# RESPONSE TO OFFICE ACTION DATED 08/28/2006

09/830,279

TUNING APPARATUS FOR STRINGED

INSTRUMENT

FIG. 10

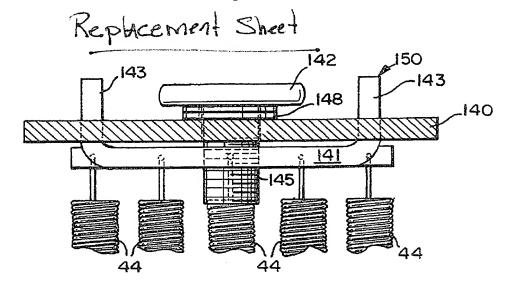
Amended drawings in compliance with CFR 1.121 (d) now indicating "alternate anchoring point (177)" in Figure 11, is marked "Replacement Sheet" and is included in this Response - "the alternate anchoring point" was "illustrated in phantom in Fig. 11". See Page 17, lines 13-14.

# Figure 11. is amended to include:

- number 177, the rearward portion of intonation module 170, previously presented in phantom only;
- number 246 to denote string anchoring points on the lower portion 140 of spring block or spring blade 240 for receiving anchoring ball 160;
- number 247 to indicate the alternate string anchoring point for receiving anchoring ball 160 on the rearward portion 177 of 170;
- number 248 to indicate the "elongated cylindrical passageway" in the string blade or spring block.
